ACCESSION NBR: 9810230020      DOC.DATE: 98/10/15      NOTARIZED: NO      DOCKET #  
FACIL: 50-269 Oconee Nuclear Station, Unit 1, Duke Power Co.      05000269  
50-270 Oconee Nuclear Station, Unit 2, Duke Power Co.      05000270  
50-287 Oconee Nuclear Station, Unit 3, Duke Power Co.      05000287

SUBJECT: Forwards response to NRC 981014 RAI re util proposed license amend to perform Keowee emergency power ESF testing during current Unit 3 refueling outage.

Subject: Oconee Nuclear Station  
Docket Nos. 50-269, -270, -287  
Request for Amendment  
Keowee Emergency Power Engineered Safeguards  
Functional Test  
Response to Request for Additional  
Information

RESPONSE TO REQUEST FOR ADDITIONAL INFORMATION  
REQUEST FOR AMENDMENT KEOWEE EMERGENCY POWER ENGINEERED  
SAFEGUARDS FUNCTIONAL TEST

# ECCS OVERVIEW

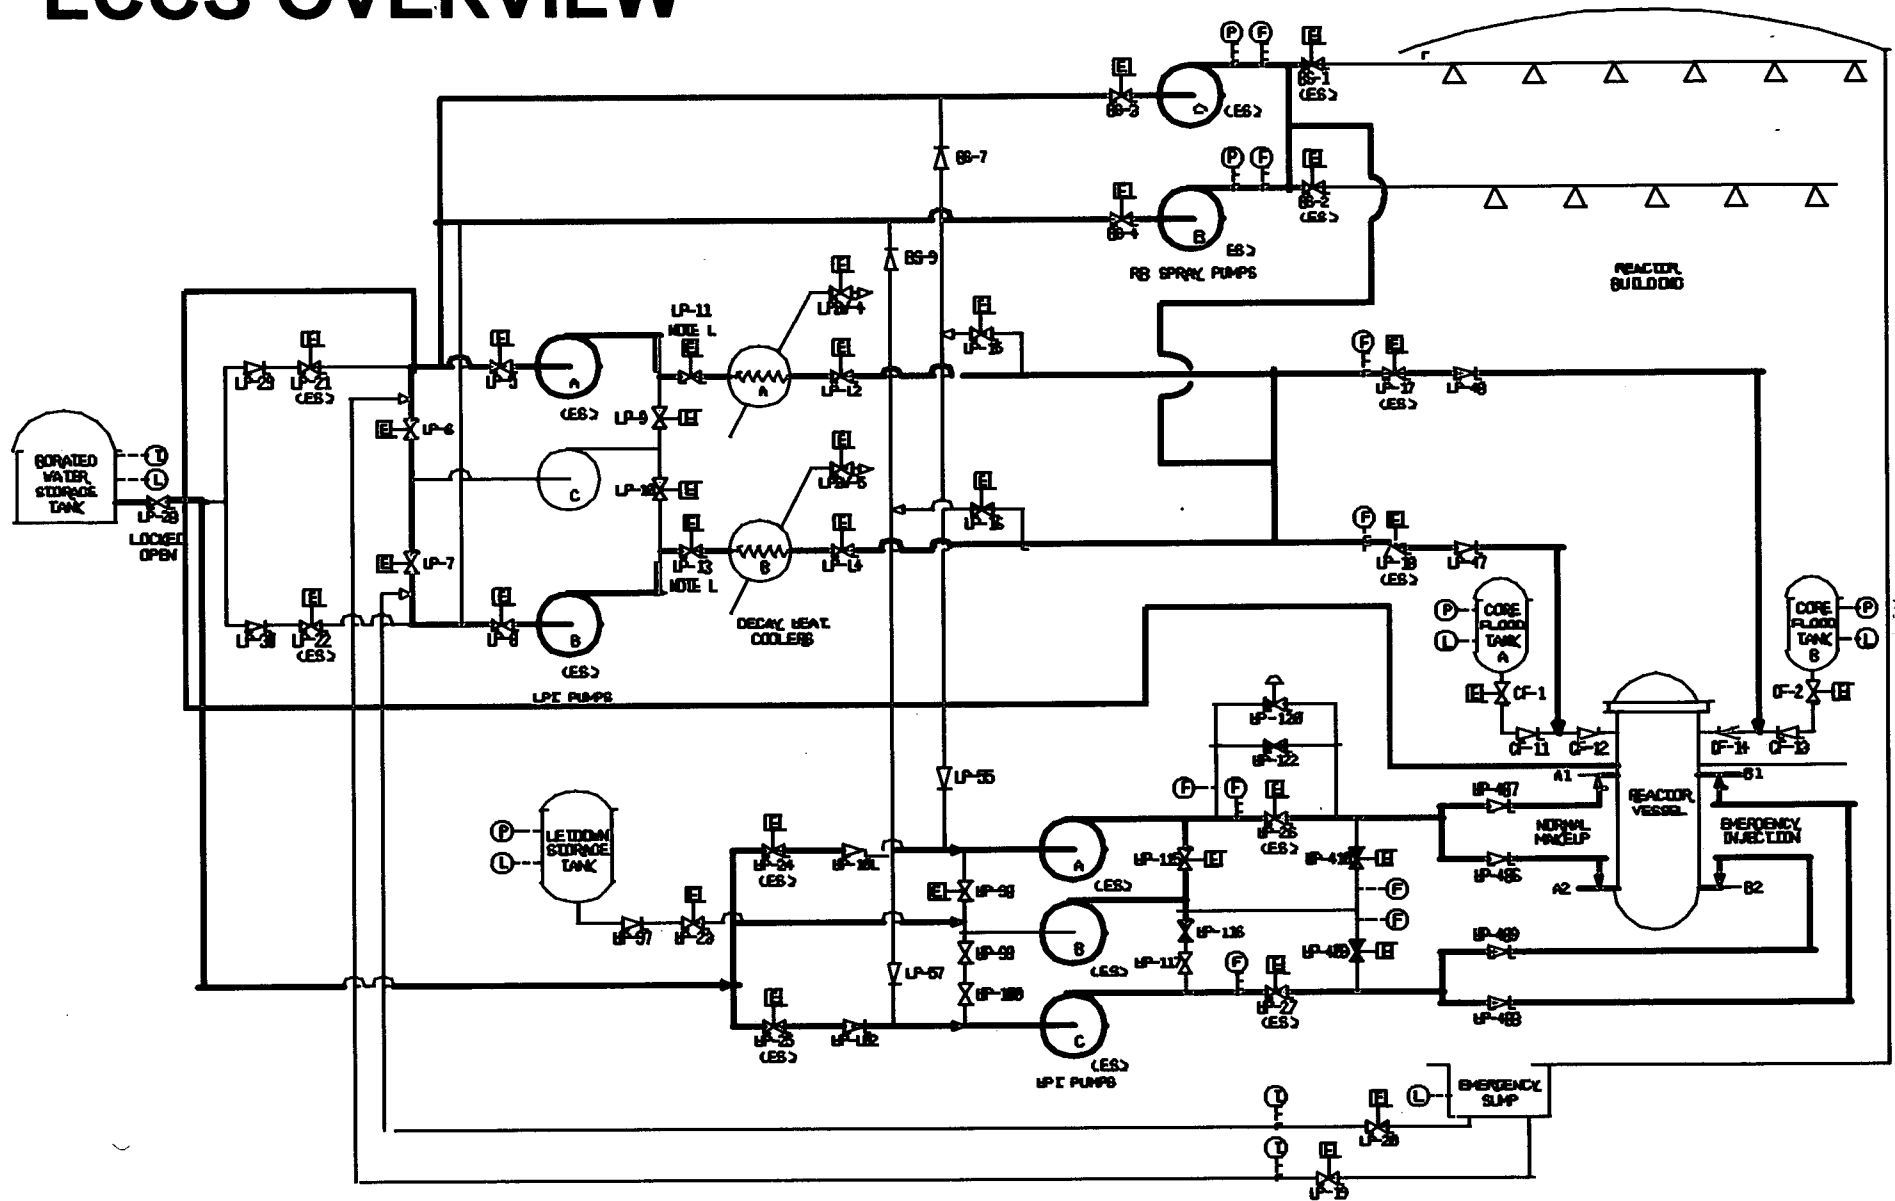
Please provide a flow diagram of the LPI and RBS taking suction from both the suction header and the RCS drop line and the discharge flow path. What is the maximum credible amount of leakage out of the RCS through the LPI or RBS?

See ECCS drawing on page 5.

Normal ECCS suction to the LPI and RBS pumps from the BWST through LP-21 and LP-22 will be isolated for this test. Suction will be from the RCS hot leg via the decay heat drop line as shown in green on the ECCS drawing. Maximum credible leakage out of the RCS through the LPI or RBS will be no more than 2 gallons per hour which is the maximum design leakage as allowed by technical specification.
